**COMMONWEALTH OF KENTUCKY**

**BEFORE THE PUBLIC SERVICE COMMISSION**

**In the Matter of:** )  
 )  
**Electronic Application of Kentucky** )  
**Power Company For 1) A Certificate** )  
**of Public Convenience and Necessity** )  
**to Construct a Mechanical Draft** )  
**Cooling Tower at the Mitchell Plant,** )  
**2) Approval of Certain Regulatory** ) **Case No. 2026-00001**  
**And Accounting Treatments, and 3)** )  
**All Other Required Approvals and** )  
**Relief** )  
 )  
 )  
 )  
 )  
 )

**DIRECT TESTIMONY OF LUCY METZ**

6 **Figure 1. Kentucky Power capacity position (2026-2040)**

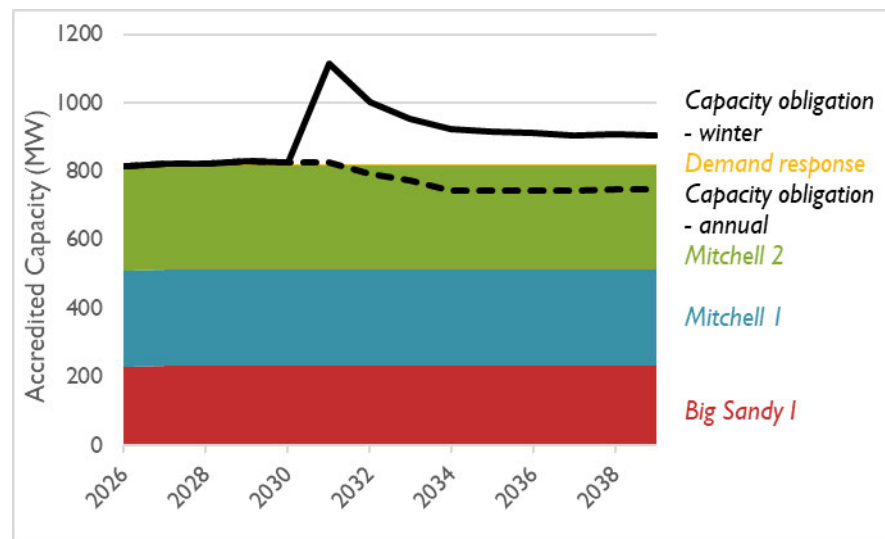
**A** Figure 1 shows Kentucky Power’s projected capacity obligation and its existing resources. Because it is a winter-peaking utility, Kentucky Power expects that PJM’s methodology to calculate its capacity obligation will change beginning in planning year 2031/2032.<sup>14</sup> This methodology change will result in Kentucky Power having a capacity need of 296 MW in 2031/2032, declining to 84 MW by 2039/2040.<sup>15</sup> The sudden capacity need starting in 2031/2032 is entirely a result of the methodology change, rather than load growth. Kentucky Power expects that its peak load will gradually decline through 2040; the Company’s annual peak load will decrease by 4 percent from 2026 to 2040 while its winter peak will decrease by 15 percent.<sup>16</sup> In the absence of any changes to PJM’s methodology,

1 the Company’s capacity obligation would show a corresponding decline through  
2 2040 (dotted line in Figure 1).<sup>17</sup>

3 Kentucky Power will therefore need to procure capacity to fill its capacity  
4 shortfall starting in planning year 2031/2032. If the Company chooses to retire  
5 Mitchell 2, it will need to procure 305 MW of additional replacement capacity.<sup>18</sup>

**Figure 2. Capacity-weighted average years in service of U.S. coal-fired units at retirement**

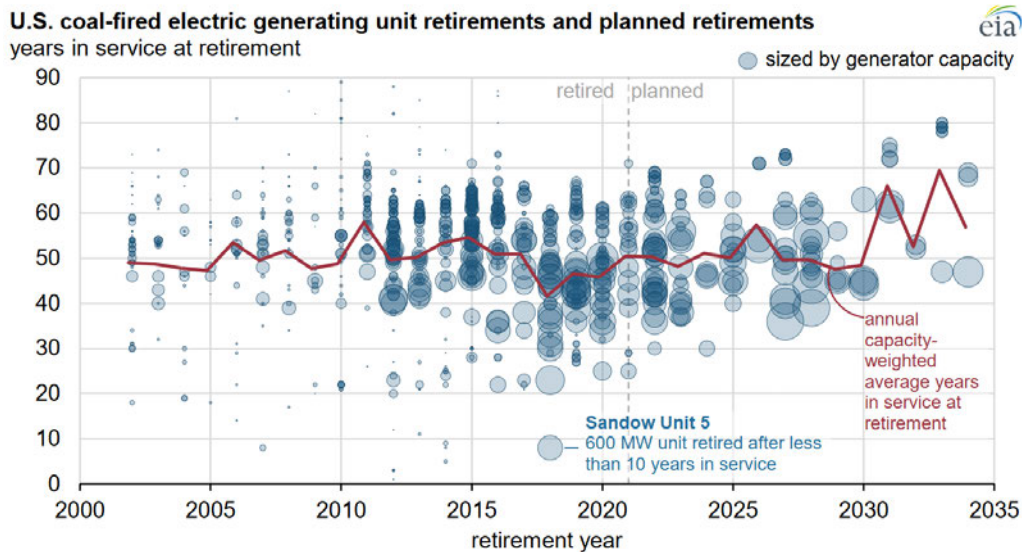
5 **A** Yes. Kentucky Power’s resource mix is almost entirely composed of aging steam  
6 turbine capacity (Table 4). Mitchell 1 and 2 are currently 55 years old and will be  
7 69 years old by their planned retirement in 2040. Big Sandy is 63 years old and  
8 will be 78 by its planned retirement in mid-2041.<sup>78</sup> Data from the U.S. Energy  
9 Information Administration suggests that the capacity-weighted average age of  
10 U.S. coal plants at retirement is approximately 50 years (Figure 2). All three of  
11 Kentucky Power’s units have exceeded this age, suggesting that they are likely  
12 reaching the end of their useful lives.

10 **Figure 3. Mitchell 2 historical capacity factor**

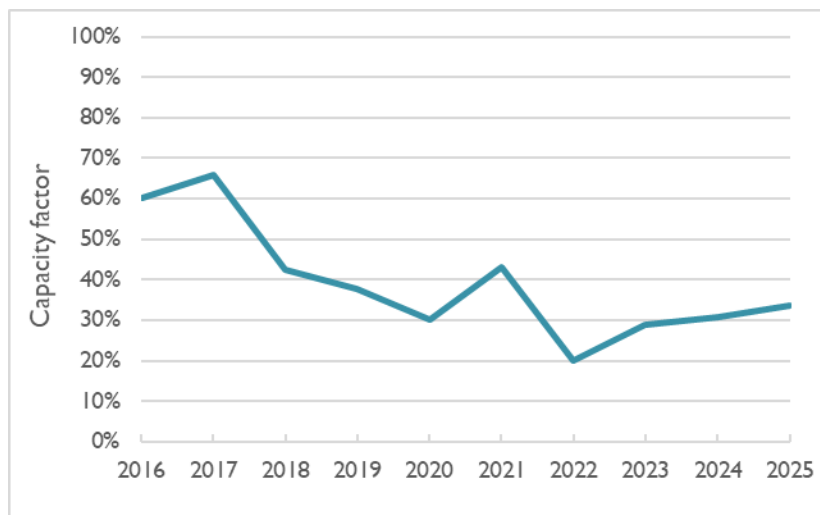
5 **A** Rising levels of renewables and other zero-marginal cost and low-operating cost  
6 resources are pushing coal units such as Mitchell 2 out of the baseload role for  
7 which they were designed and into load-following roles that they are poorly suited  
8 to fill. Historical generation data for the unit shows its capacity factor decreasing  
9 from 60 percent in 2016 to only 34 percent in 2025 (Figure 3).

**Figure 4. Historical Henry Hub natural gas price (nominal \$ / MMBtu)**

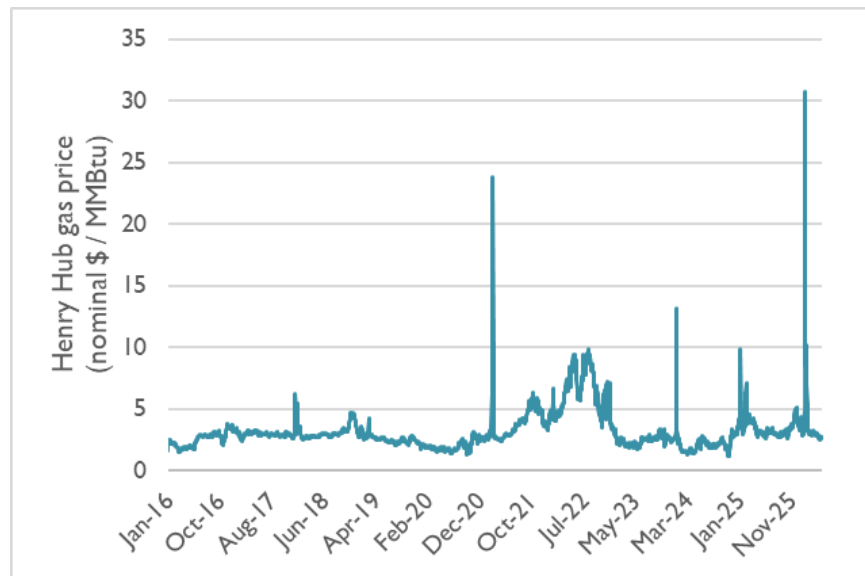
9 Gas CC plants come with risks of their own. As with coal plants, a gas CC plant is  
10 a capital-intensive asset that will lock in ratepayer funds over the 35-year lifetime  
11 of the plant.<sup>92</sup> High demand for gas turbines across the country has meant that  
12 new resource prices are currently elevated, and equipment lead-times are long.<sup>93</sup>  
13 The Company would also need to secure firm gas supply for a new CC plant,  
14 which adds fixed costs over the life of the resource. Finally, CC plants expose  
15 ratepayers to gas price volatility (Figure 4).
